SUBJECT: Sea World Lease Amendment

CITY PLANNING COMMISSION
RESOLUTION NO. 5460

CONDITIONAL APPROVAL OF SEA WORLD MASTER PLAN
AND RED LION HOTEL ON THE SEA WORLD LEASEHOLD

Proposed Intersection Modification — Ingraham Street & Perez Cove Way

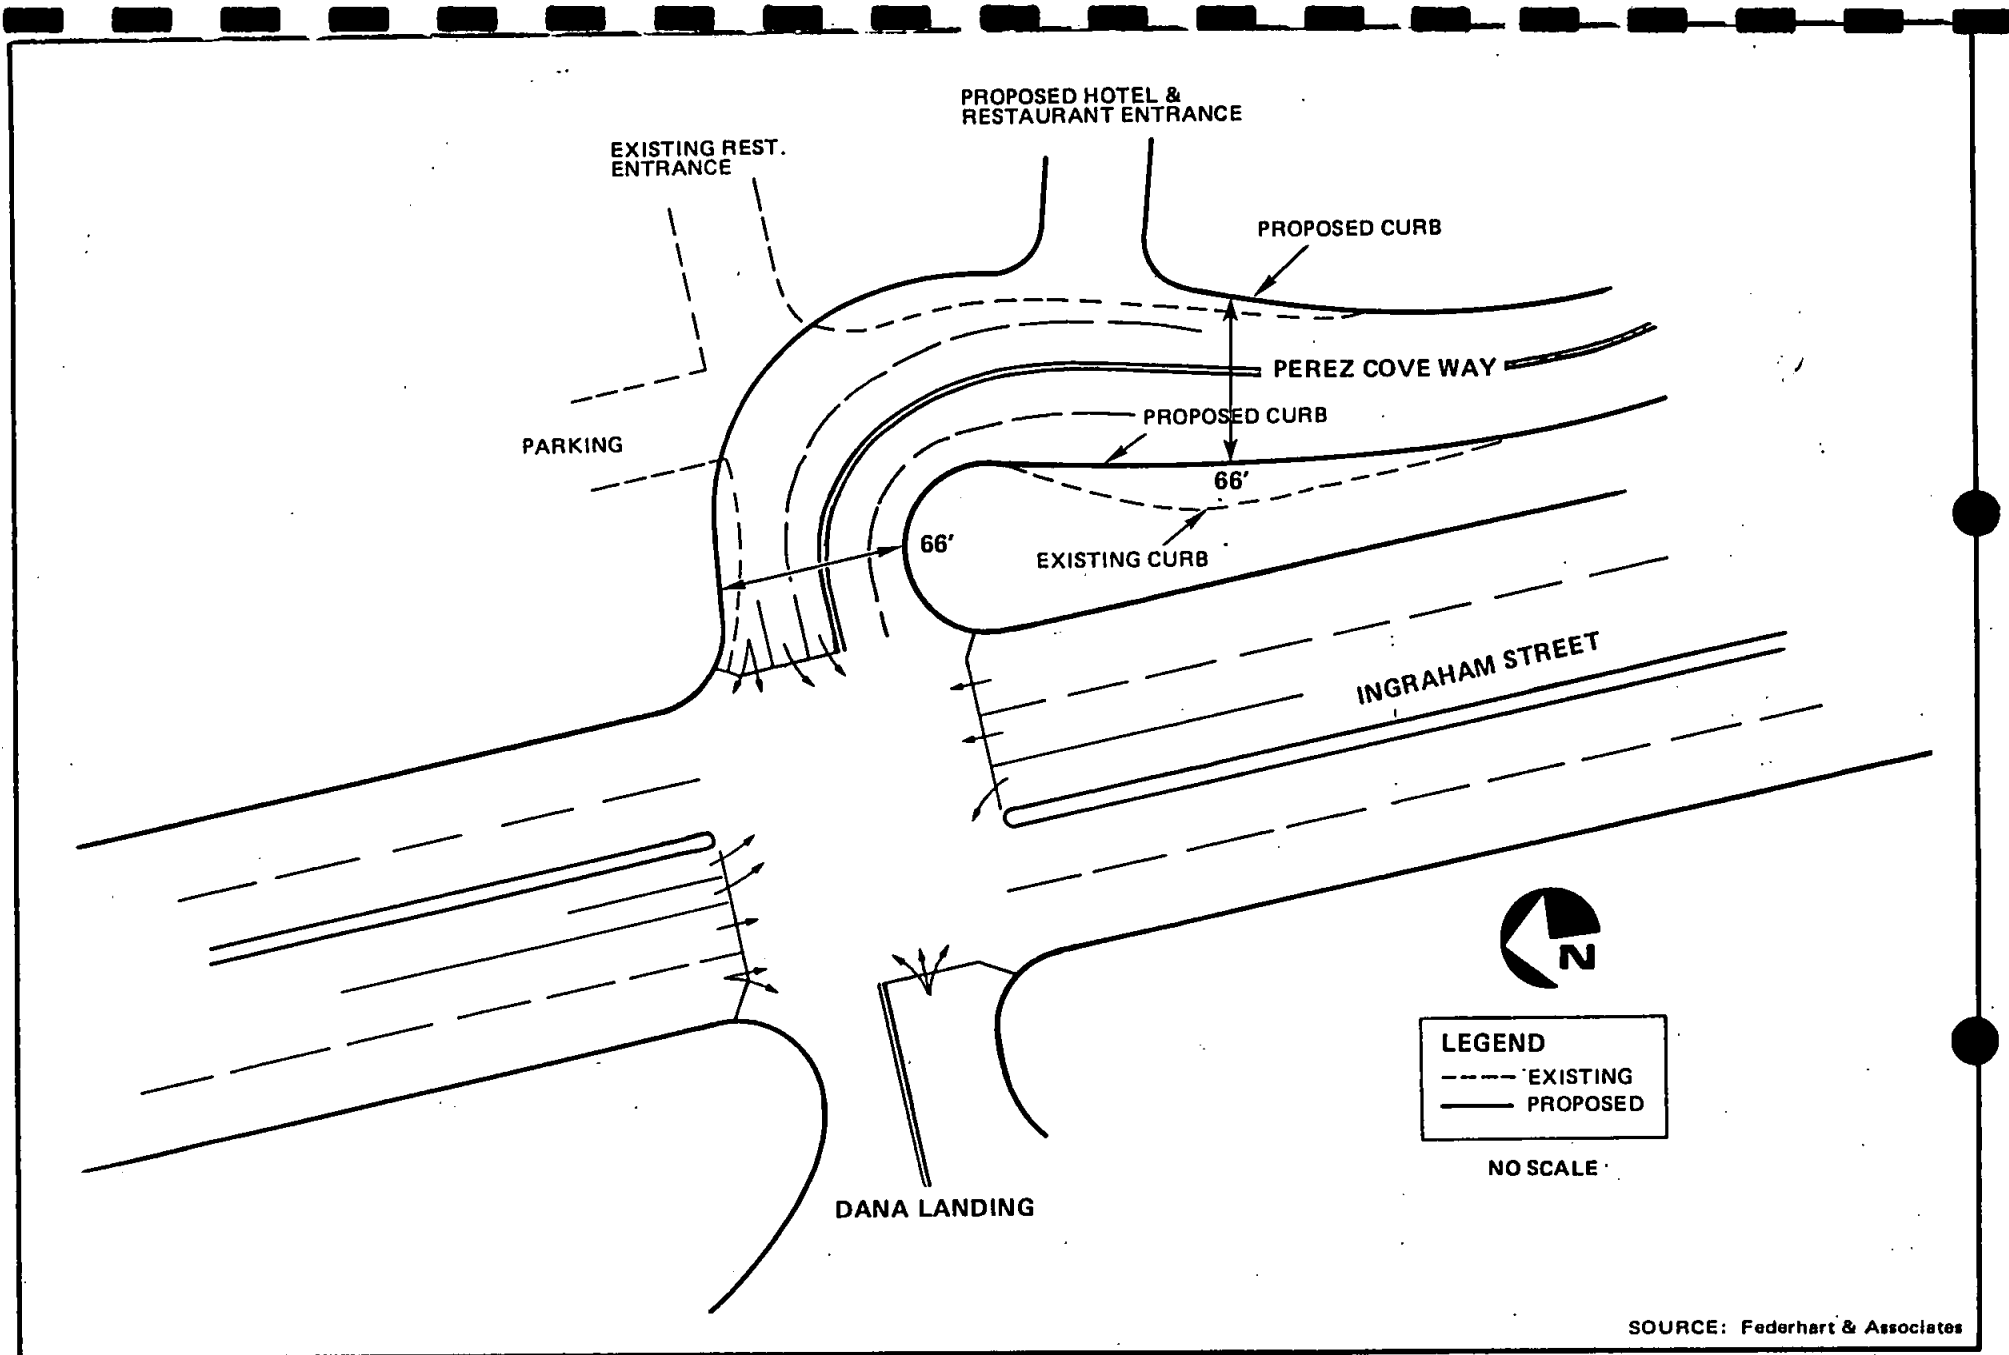
1. On page 2-5, Figure 2-4, the proposed master plan graphic incorrectly shows driveway configuration on Perez Cove Way near the Ingraham Street intersection. It will also be necessary to further revise this graphic to show other required mitigation as specified later in this memo.

16. Page 4-16, Figure 4-4, should indicate 66' not 58' width on Perez Cove Way. The proposed bicycle lane should also be shown.

1. A caveat has been added to Figure 2-4, stating that additional developments associated with the Master Plan are on file with the Planning Department. Figure 4-4, available in the EIR and on file with the Planning Department, shows detail of the Perez Cove Way/Ingraham Street intersection. The Master Plan graphic originally submitted to the City and reproduced on Figure 2-4 should not be considered final or complete, as it has been subject to extensive revision.

FIGURE
4-4

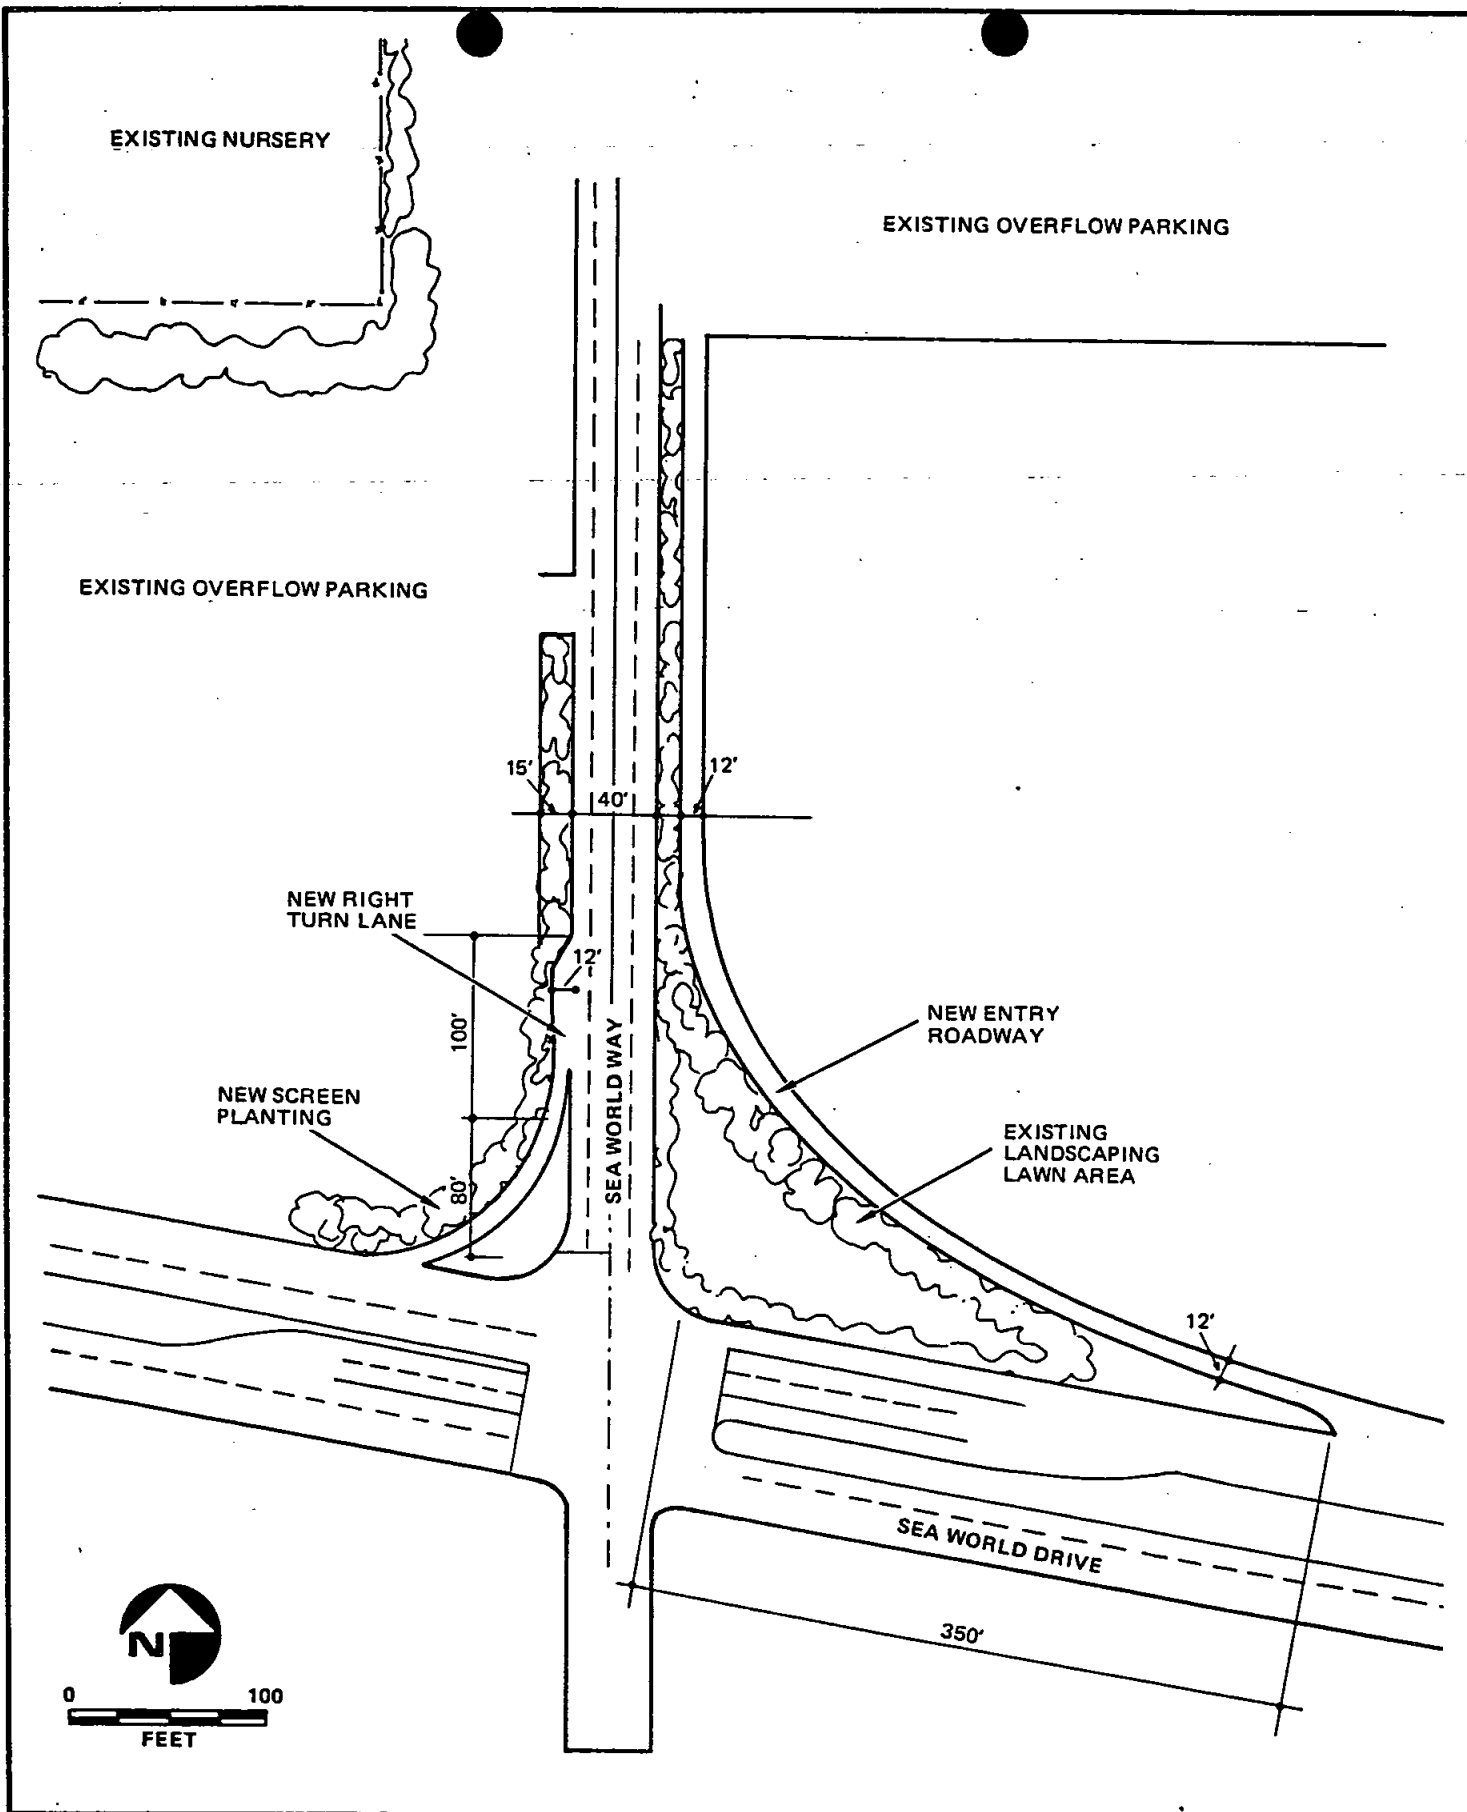
7. On page 4-18, Figure 4-5, the graphic showing the Sea World main entrance improvements should be changed. An acceleration lane should be shown on the north side of Sea World Drive, west of Sea World Way. The width of Sea World Way should be changed from 40' to 52' in order to provide standard size lanes.

9. On page 4-17, Figure 4-5, the graphic showing the Sea World main entrance improvements should be changed. An acceleration lane should be shown on the north side of Sea World Drive, west of Sea World Way. The width of Sea World Way should be changed from 40' to 52' in order to provide standard size lanes.

LANDSCAPE PLAN - SUB PARKING LOT.

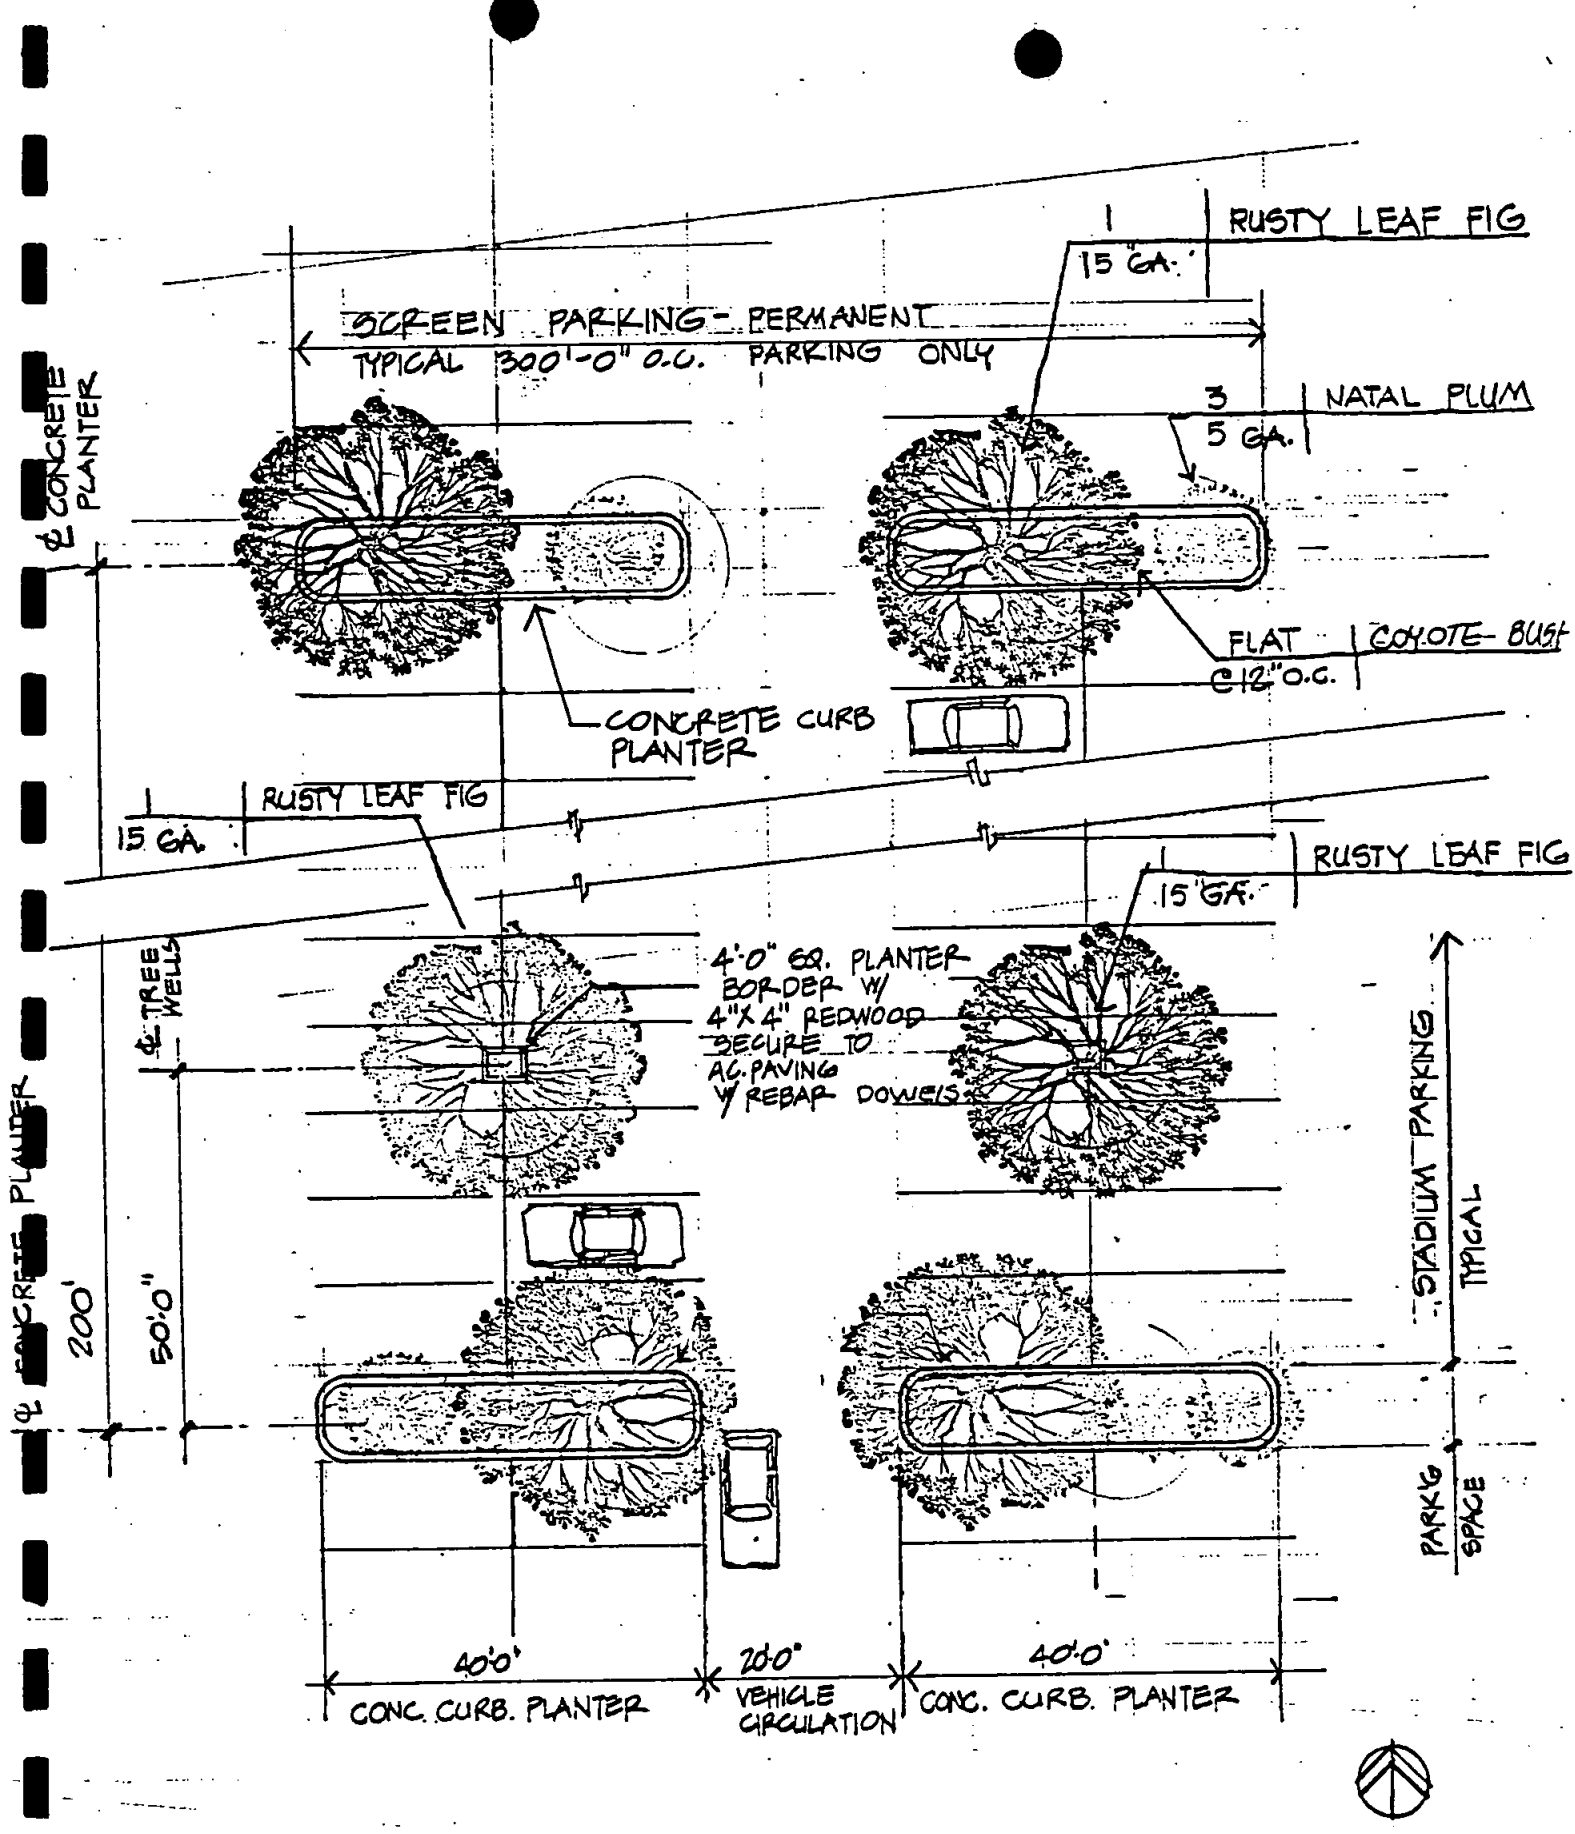
Several outstanding issues remain regarding the landscaping design. The plans show Coyote Bush planted as ground cover, except on the bermed planter (see Landscape Plan - Internal Parking Lot Screen) where English Ivy is shown. A ground cover other than English Ivy is recommended in order to conserve water and provide greater compatibility with the New Zealand Christmas Tree. Perimeter trees, designed to provide a visual screen between Sea World and adjacent properties, should be planted as specimen-size trees (e.g., 24-inch or 36-inch box) rather than the 15 gallon size shown on Figure 4-10. Additionally, the plans should specify the species that would be used for landscape screen planting (Figures 4-9 and 4-10), since eucalyptus and acacia are common names referring to literally hundreds of varieties.
